Subject: Geologic Hazards Evaluation and
Preliminary Geotechnical Investigation
Response to El Paso County Review Comments
Grandview Reserve, Phase 1, Filing 1
Eastonville Road and U.S. Highway 24
Falcon, Colorado
CTL|T Project No. CS19345-115

This letter presents our response to the El Paso County review comments dated May 9, 2023. CTL|Thompson, Inc. (CTL|T) prepared a Geologic Hazard Evaluation and Preliminary Geotechnical Investigation (CTL|T Project No. CS19345-115, dated May 9, 2022) for the proposed Grandview Reserve development located east of Eastonville Road and north of U.S. Highway 24 in El Paso County, Colorado.

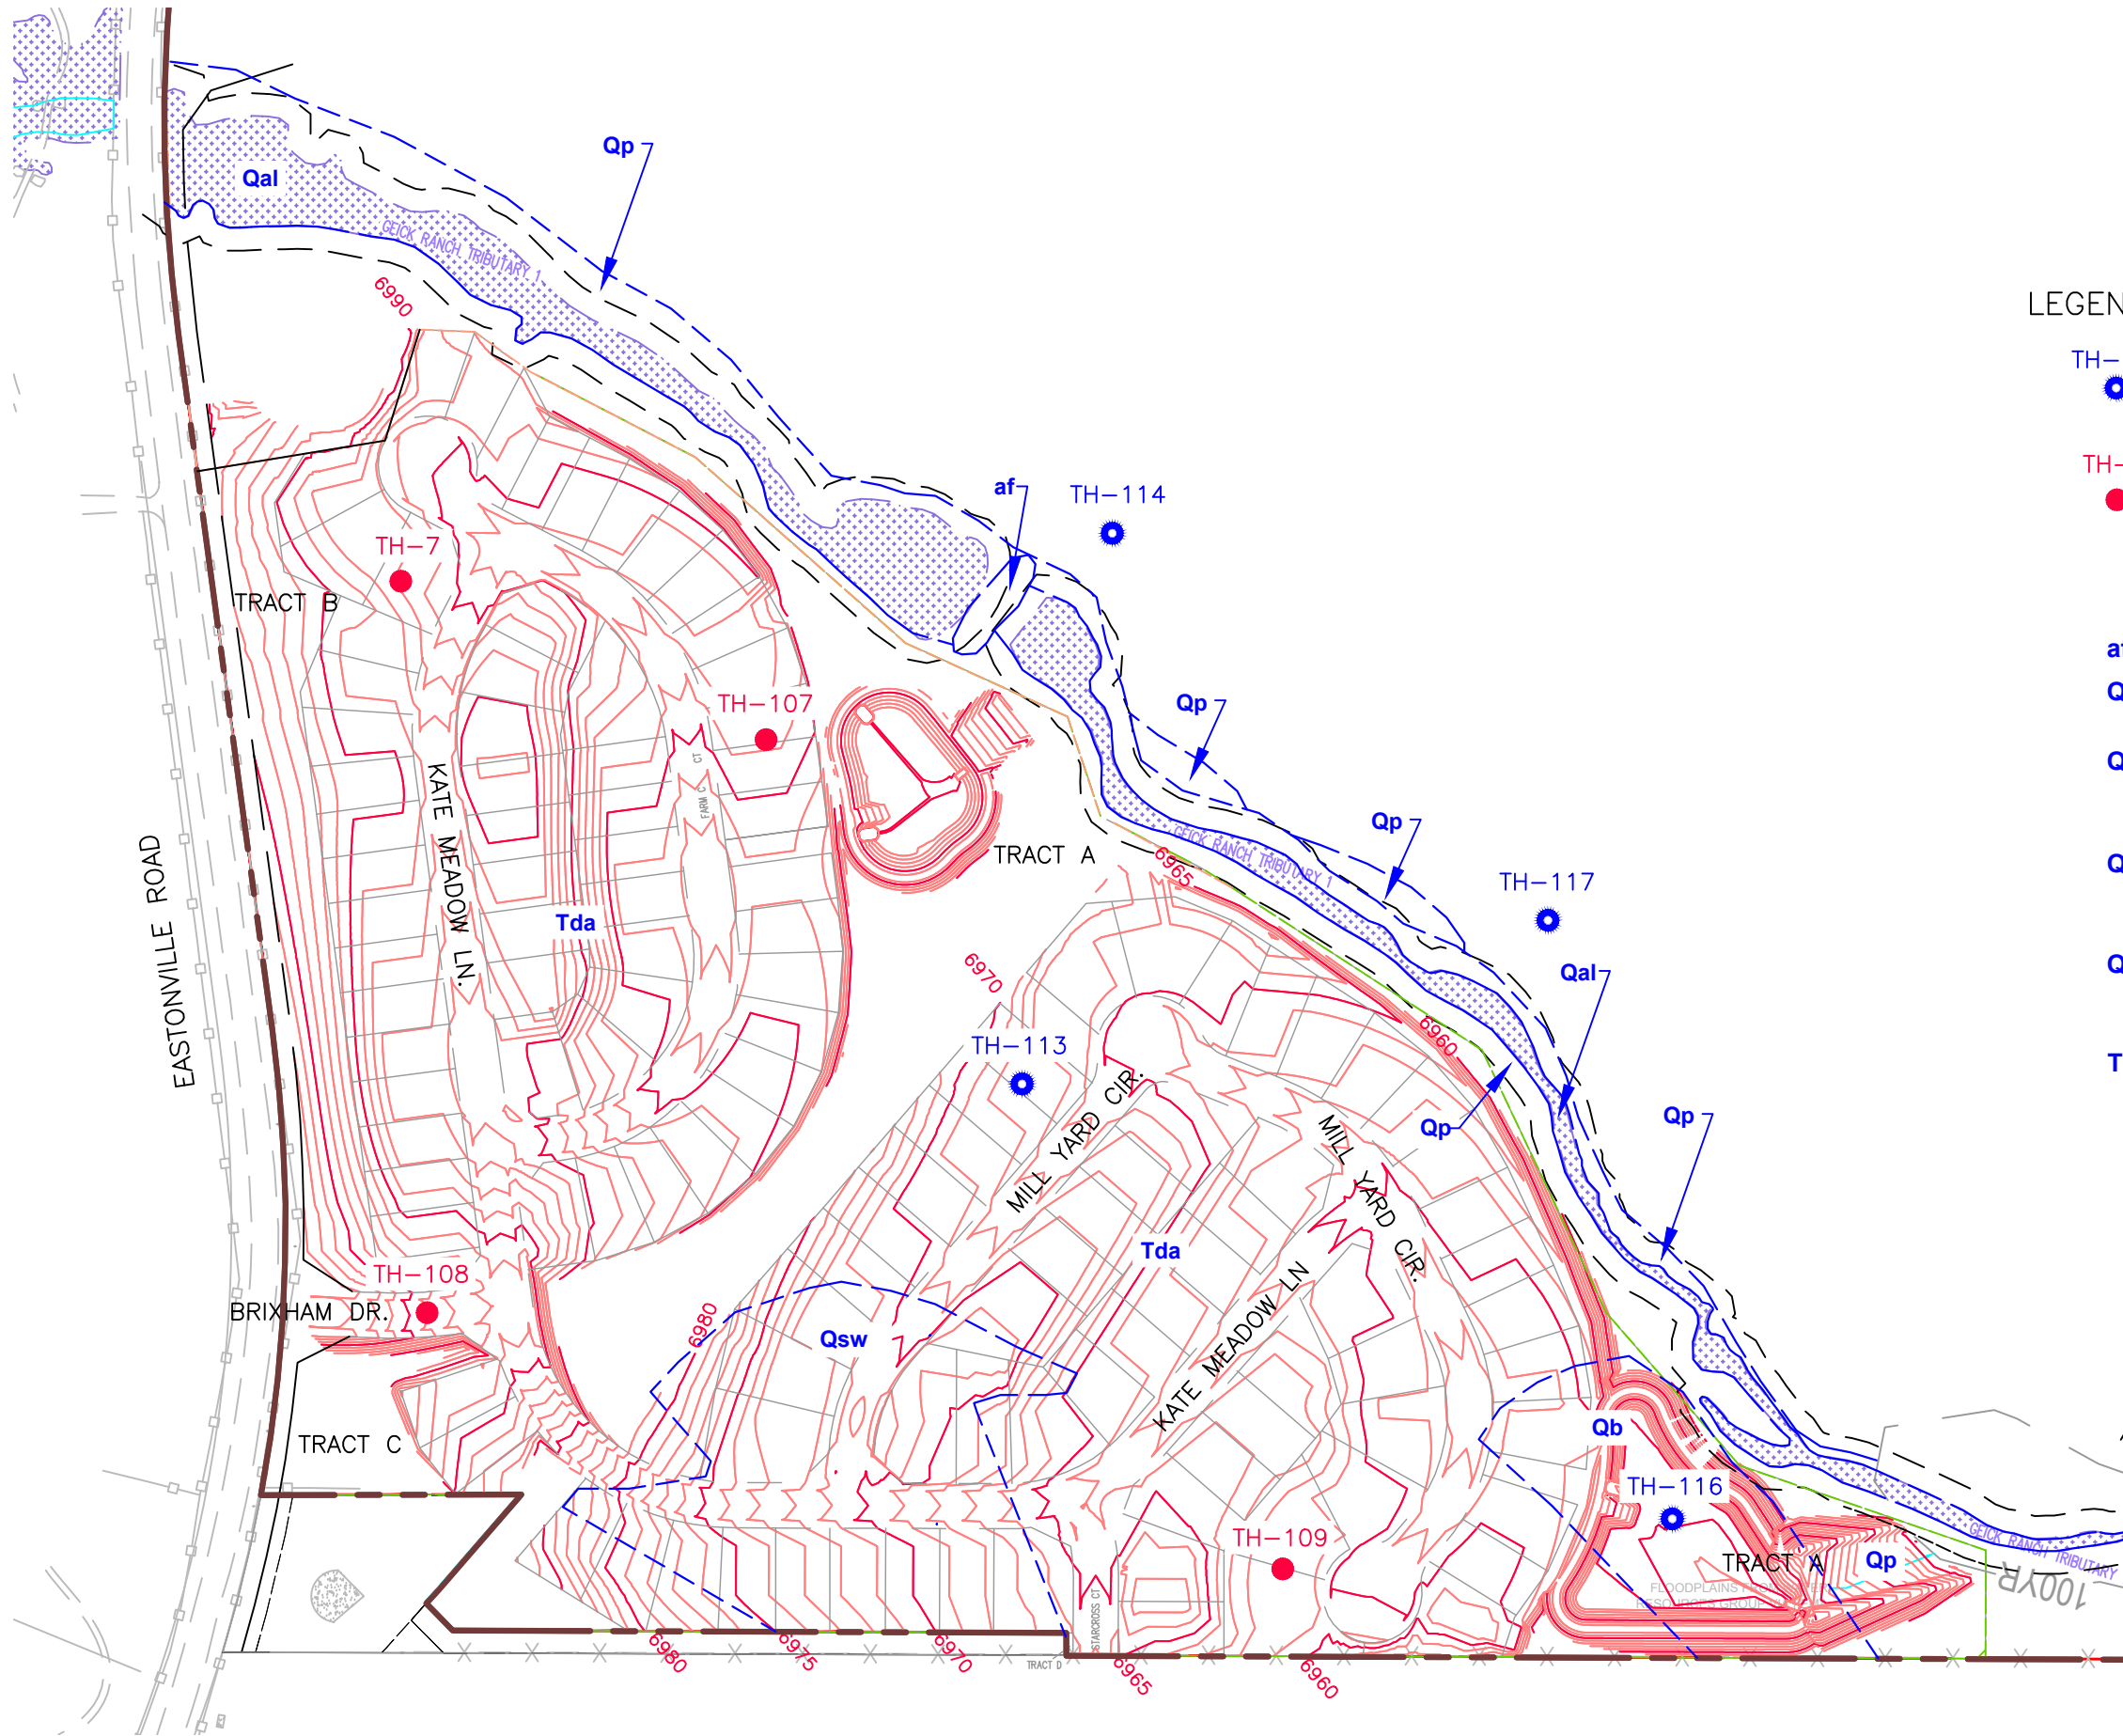
“A figure is missing depicting the various constraint and hazard mapping over the lot layout which was deferred from the prelimplan – see sample.” El Paso County requests that the subsurface conditions, site geology, and each of the geologic hazards including shallow groundwater, unusually hard rock which may cause problems with excavation, expansive soils, flooding, seismicity, erosion, radon/radioactivity, and recoverable minerals be mapped, along with estimated heave potential.

We have included a new figure attached with this letter, titled Surficial Geologic Conditions (Fig. 5), that delineates surficial geologic units across the site based on mapping and site reconnaissance. Considering the variability within the Dawson Formation, a detailed map of subsurface conditions beyond the surficial geology that is mapped in Fig. 5, cannot be produced. Additionally, the remaining geologic hazards presented in the report such as hard bedrock, seismicity, erosion, and radon/radioactivity cannot be mapped. These are generally regional hazards and it isn't possible to delineate the extents of each of the geologic hazards on every site. Attempting to do so would falsely suggest that these hazards may be possible in portions of the site and not possible in other portions of the site. A discussion of these hazards is provided in the referenced report.
